STAFF REPORT: 4/14/2021 MEETING

ADDRESS: 1627 (1627-1639) LEVERETTE

HISTORIC DISTRICT: CORKTOWN

SCOPE: ERECT NEW CARPORTS; REHABILITATE BUILDING

SHEET TITLE
Car Port Plan and Elevation

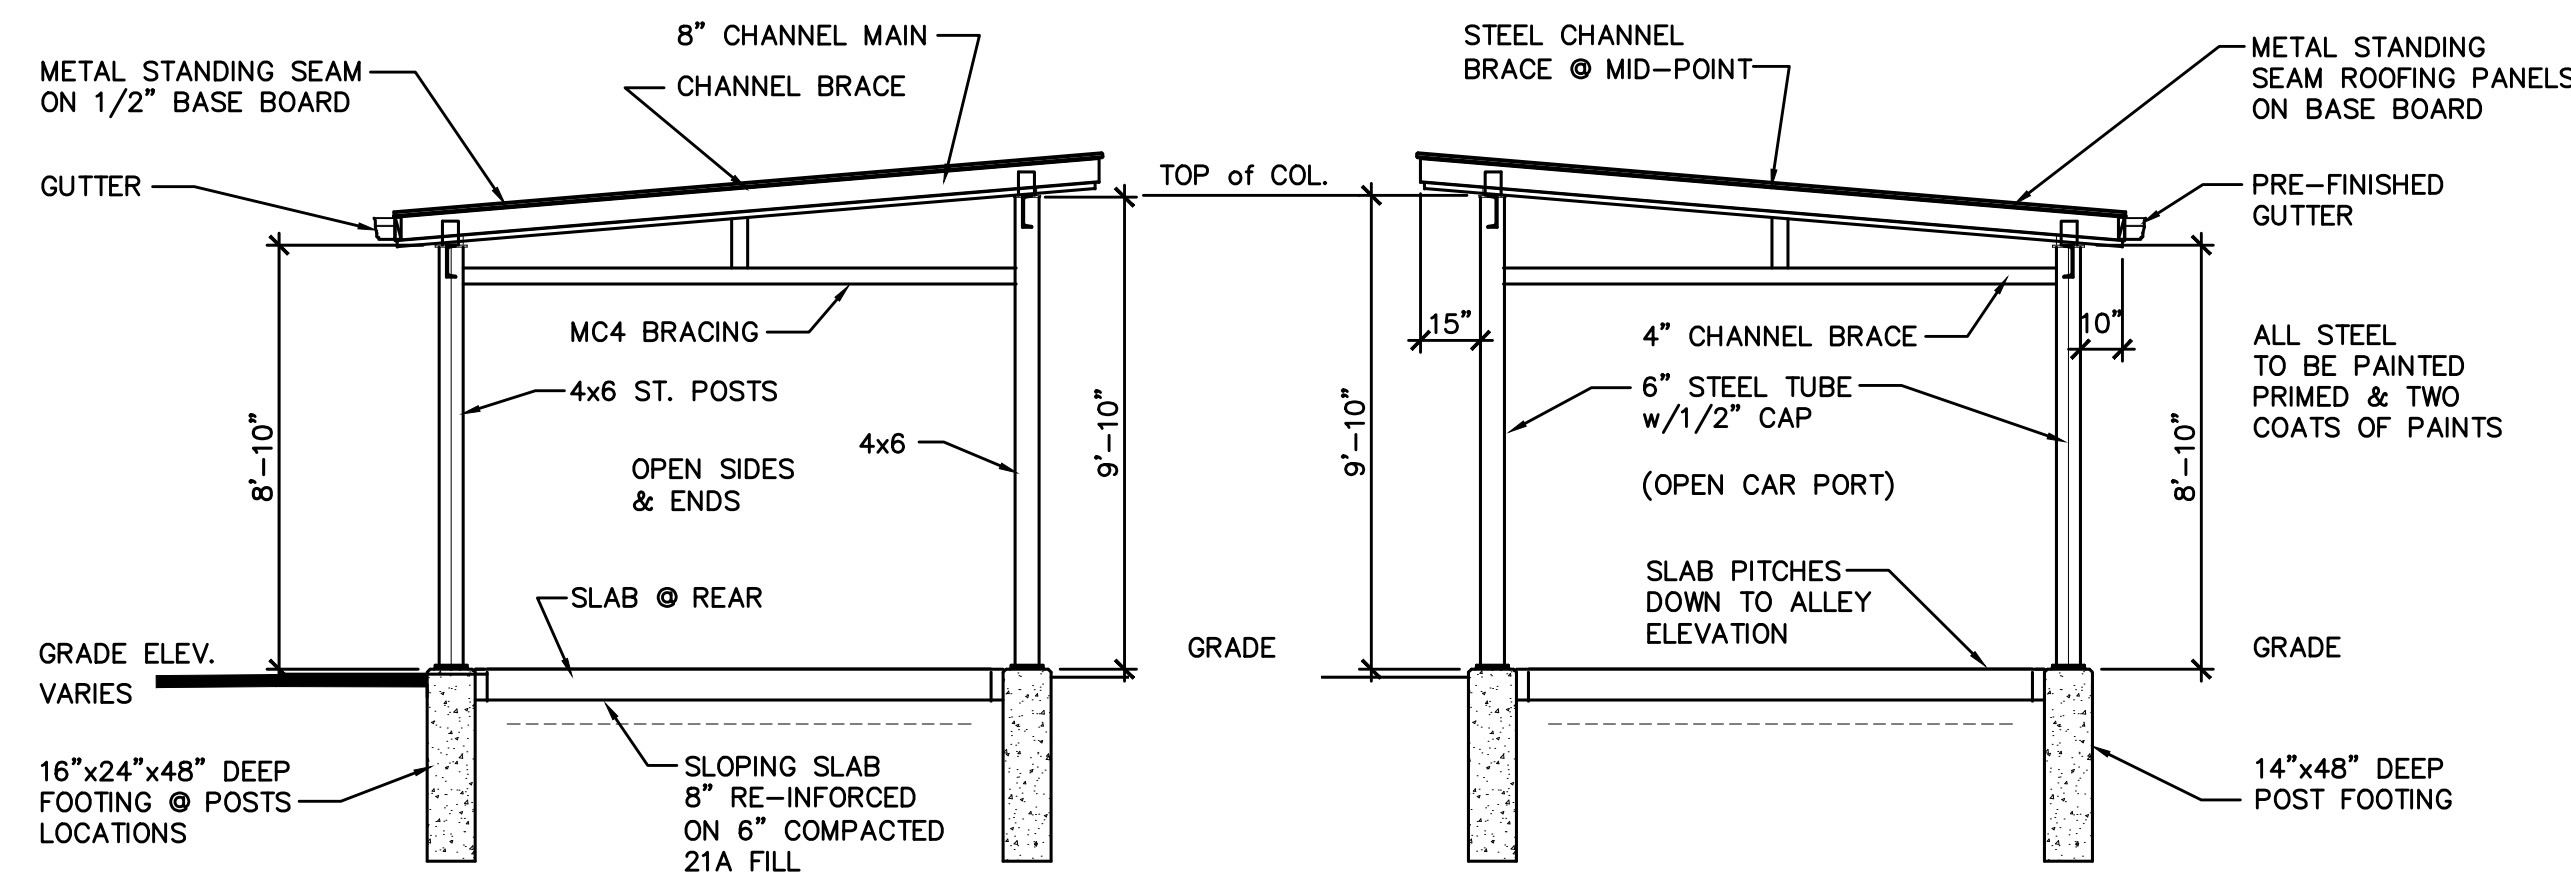
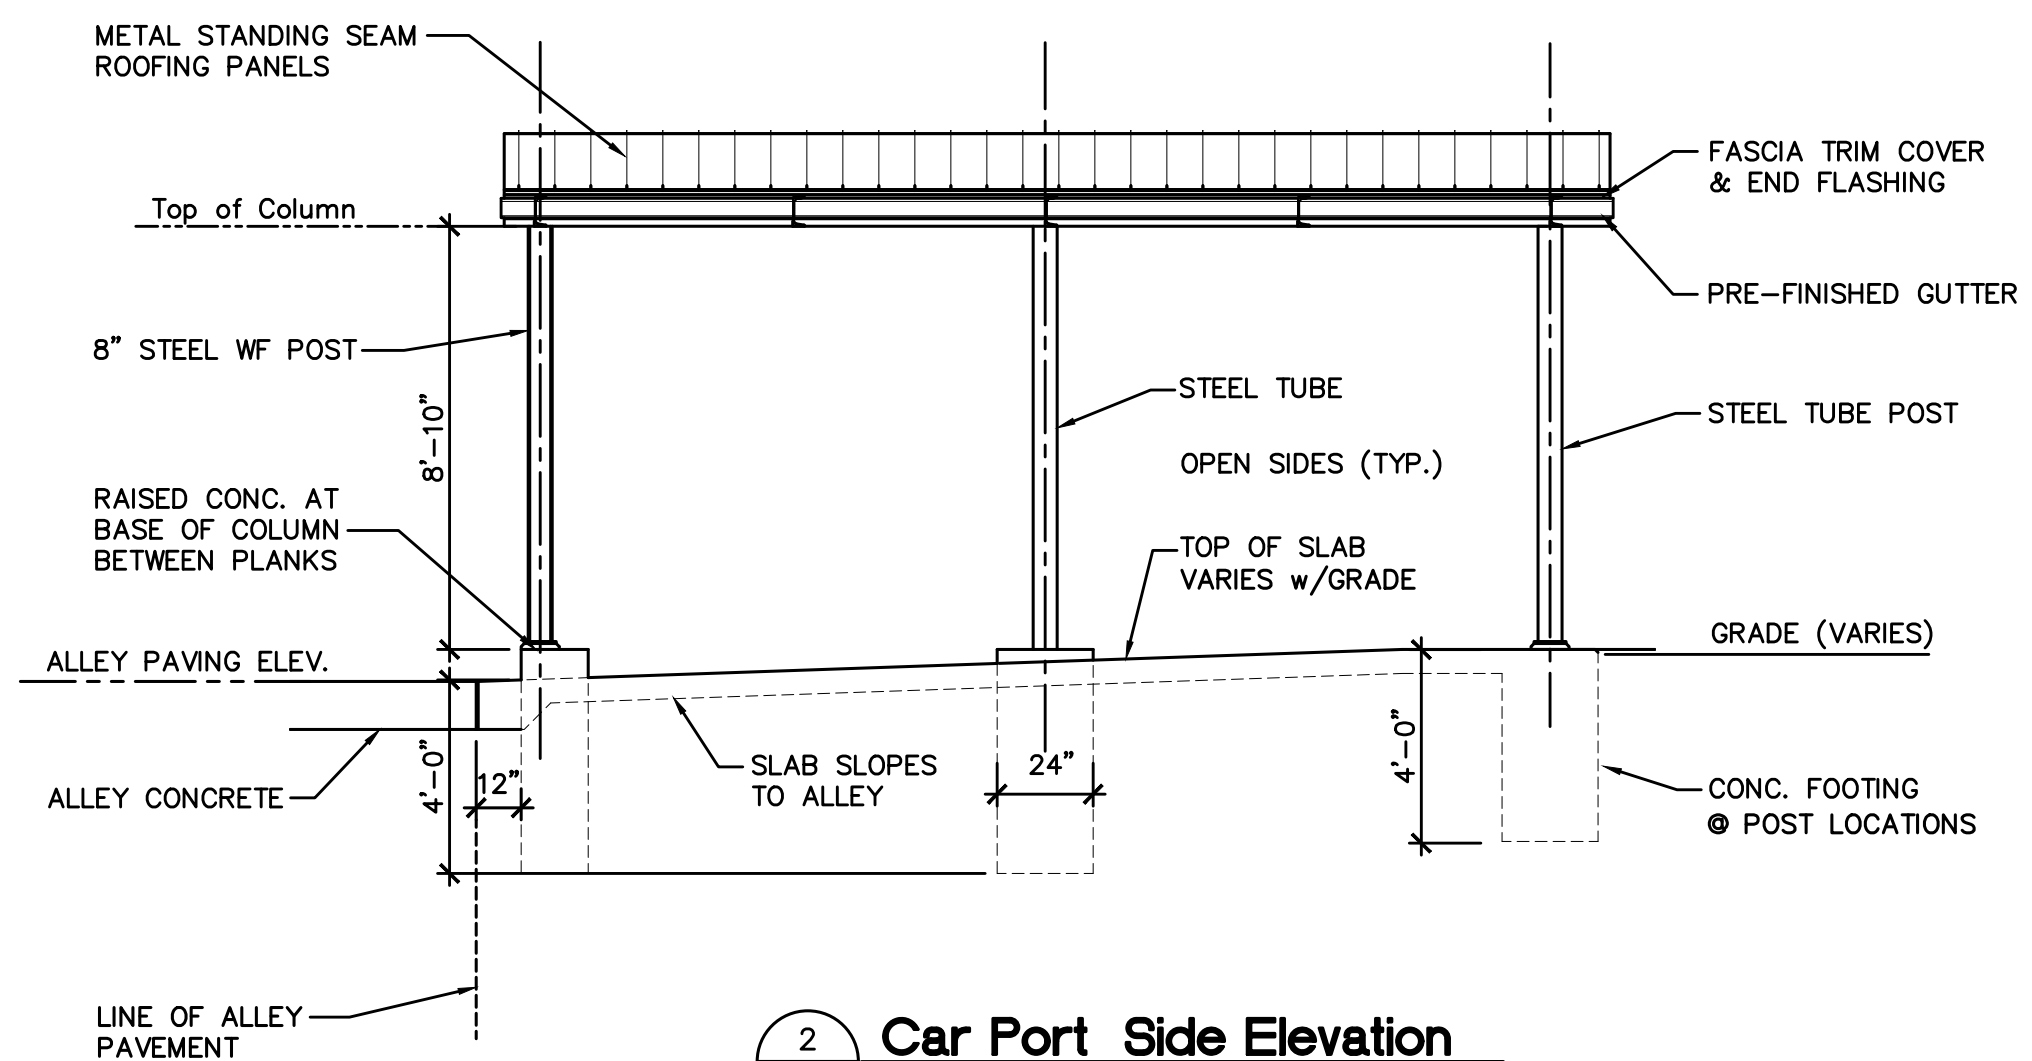
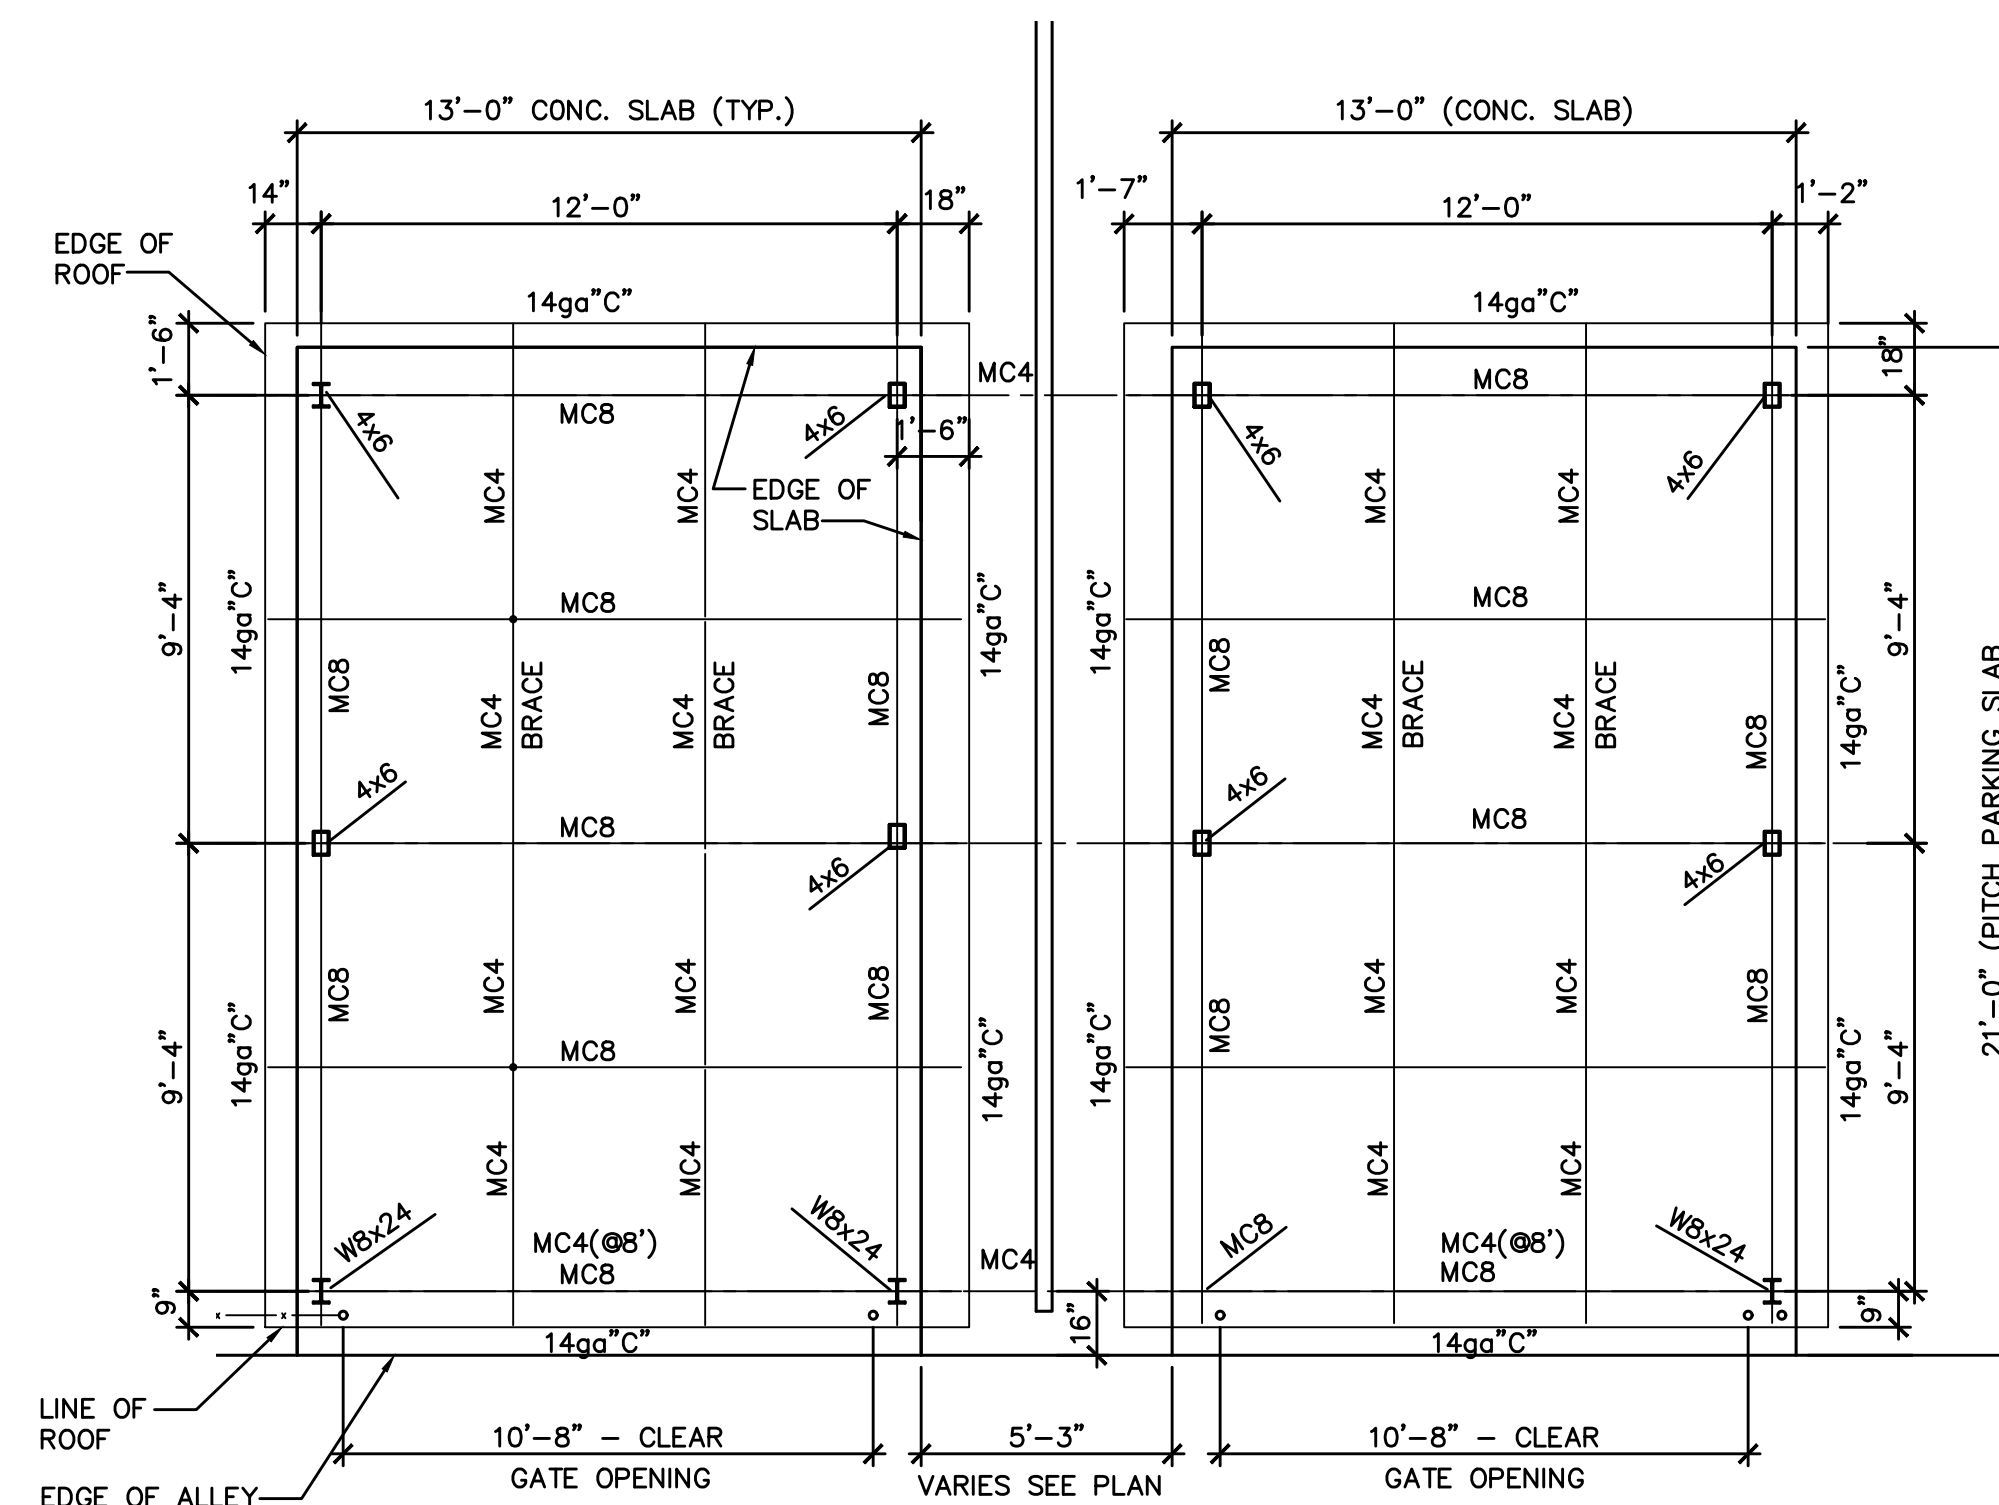
- It is staff's opinion that unpainted nature of the wood at the newly-erected fencing, gates, rear yard walls, and rear porches are not in keeping with this early 20th century building. Staff recommends that that these elements be stained or painted a color which complements the trim at the building.

- Any exterior wood elements proposed for the new carports cannot be unfinished. Rather, they must be stained or painted a color which complements the building. The owner or applicant shall submit a proposal to HDC staff outlining the color palette for the garages' wood elements for review and approval prior to staff's approval/signoff of the project's final construction drawings. Also, these elements must be painted or stained as per the approved color scheme on or before April 14, 2022.
- The swag detailing must be applied to the current RFP cornice so that it replicates the original cornice, as indicated in the submitted drawings and required by the Commission's 2018 COA
